**CHILDREN'S HOSPITAL
OF ORANGE COUNTY**
455 S. Main St.
Orange, CA 92668-3874

TOWER II

**LEVEL 1
REFLECTED
CEILING PLAN
AREA - B**

A4.1B

B2 Enlarged Plan
1/8" = 1'-0"

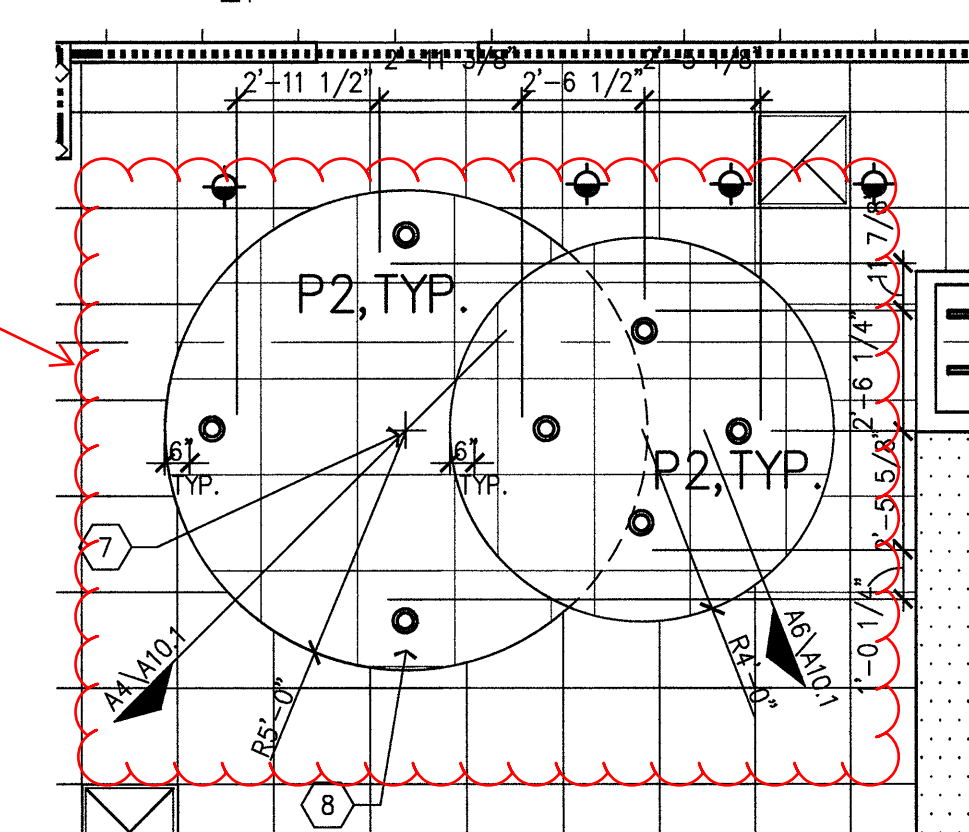
RFI #5473
RCP
Coordination
Level 1

A6 AREA B
1/8" = 1'-0"

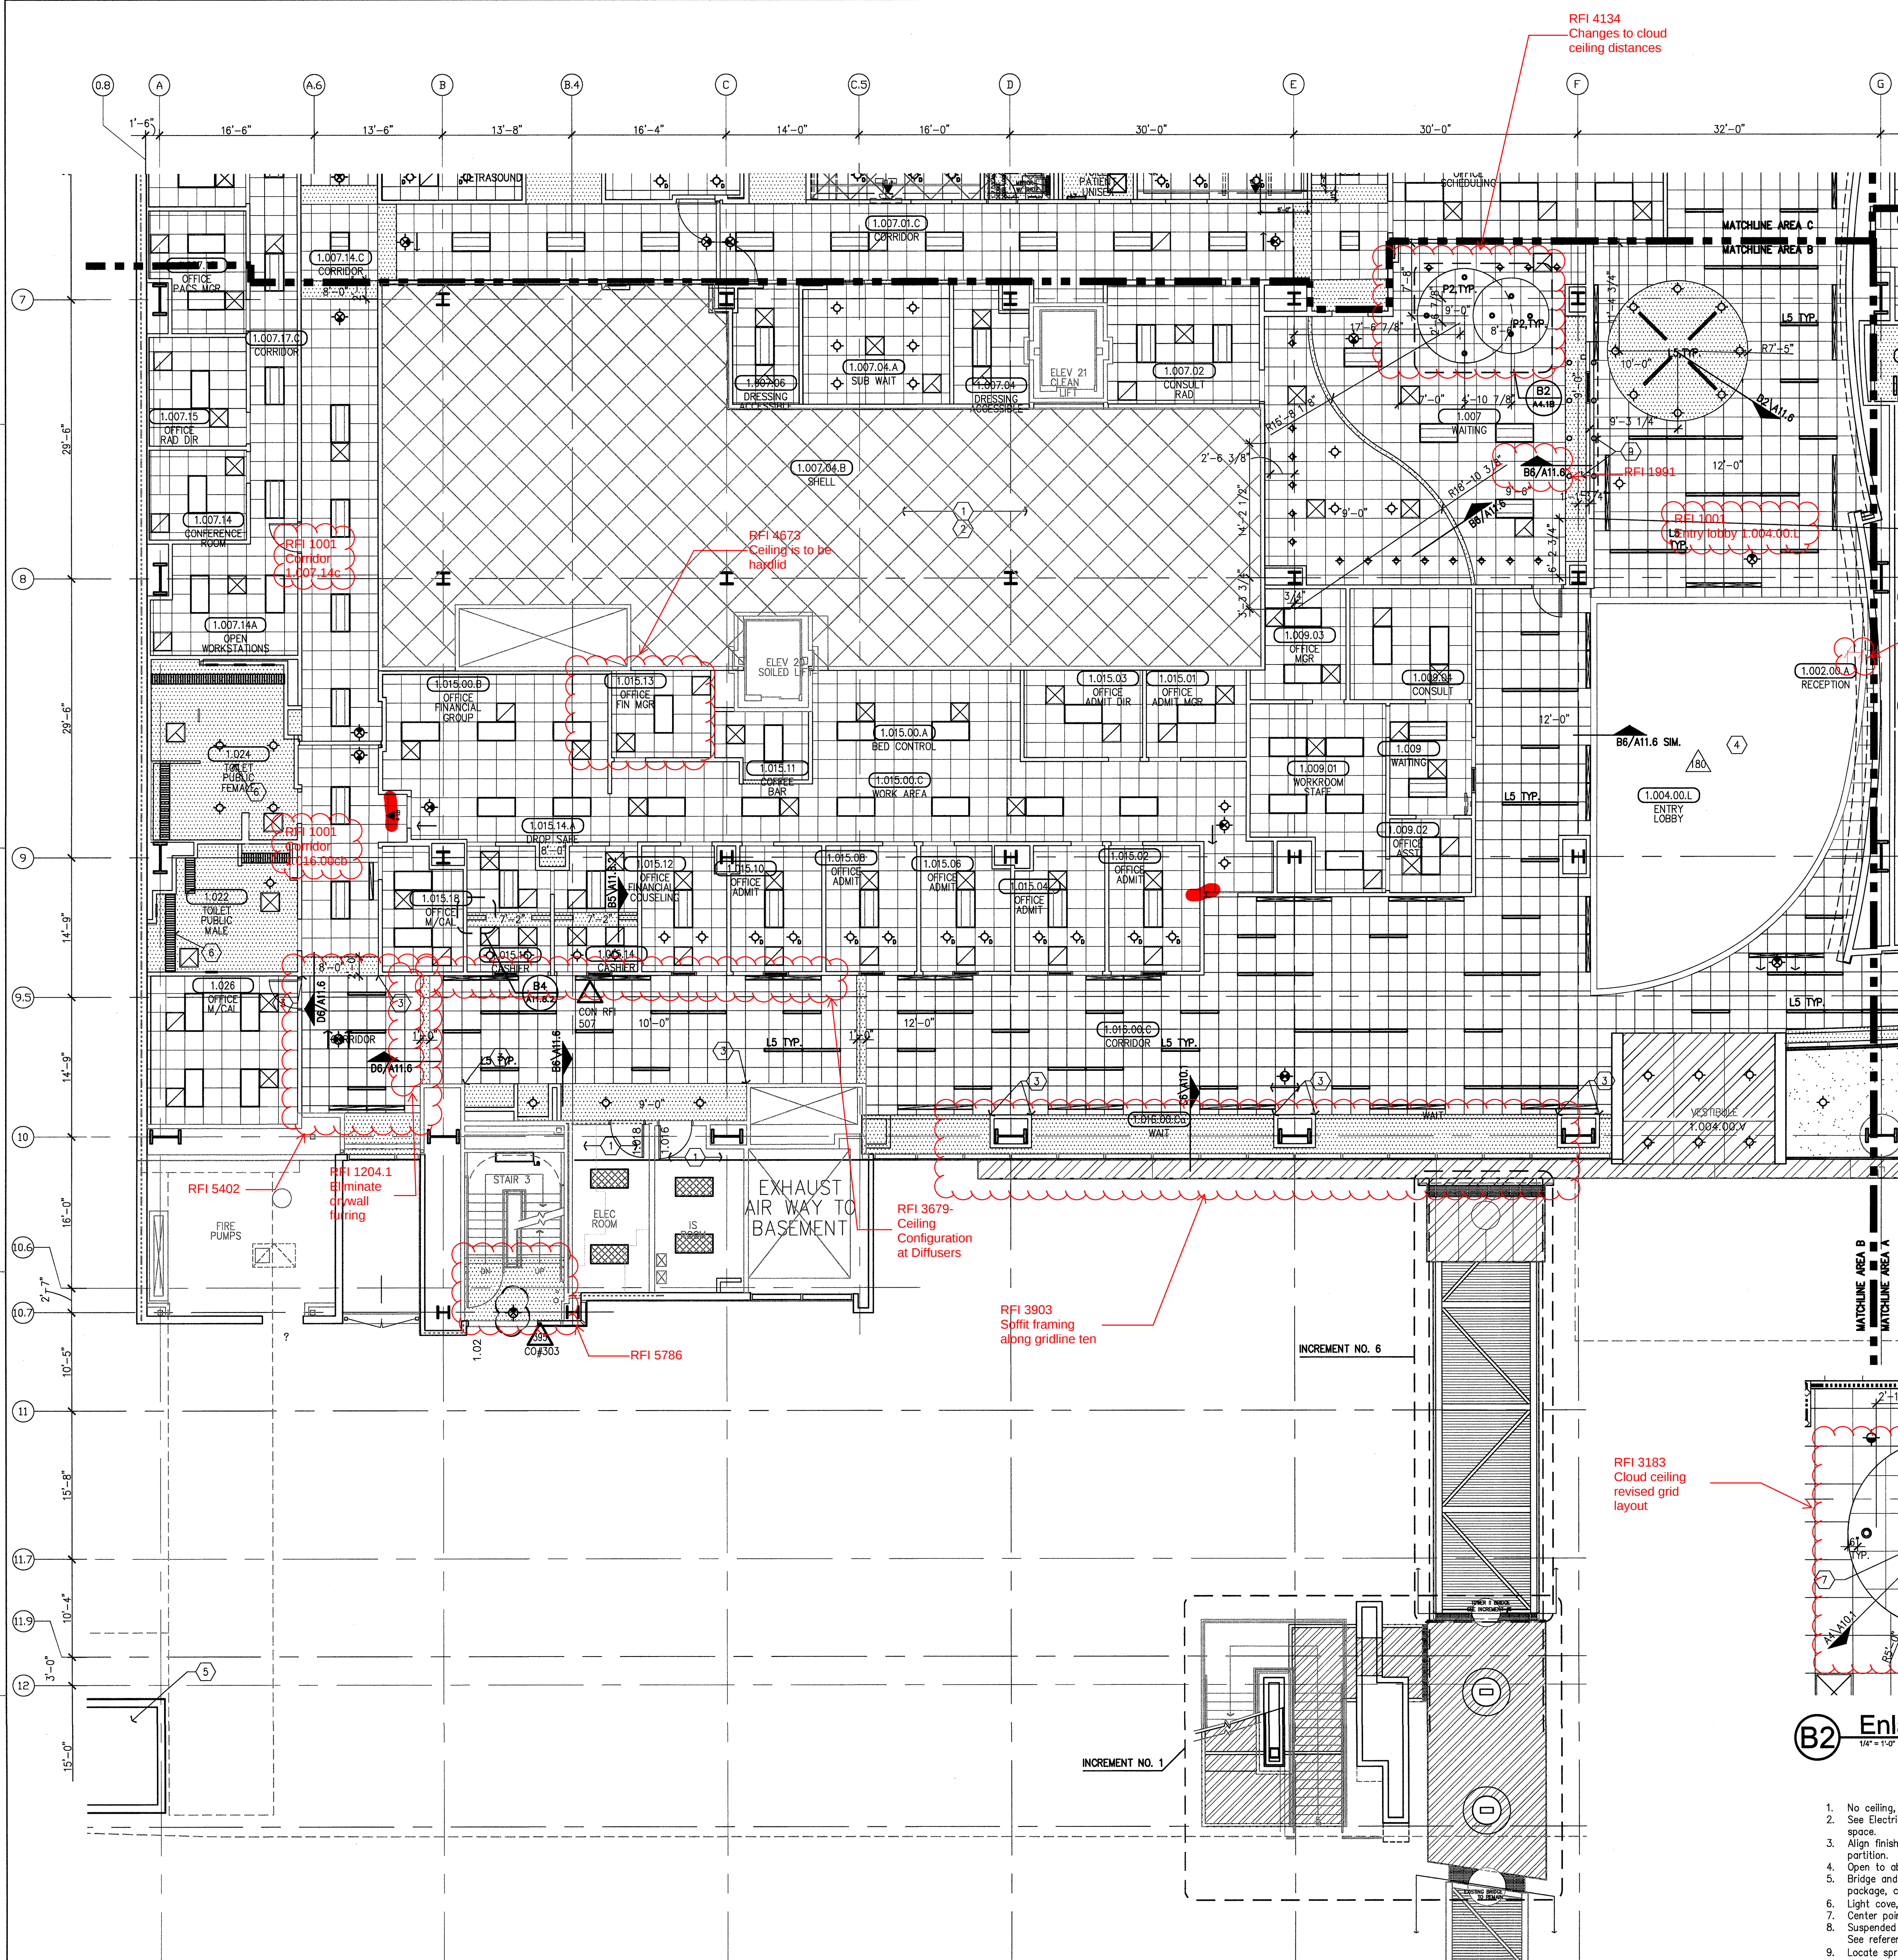
RFI 4014
See revised ceiling layout per
access panel coordination.
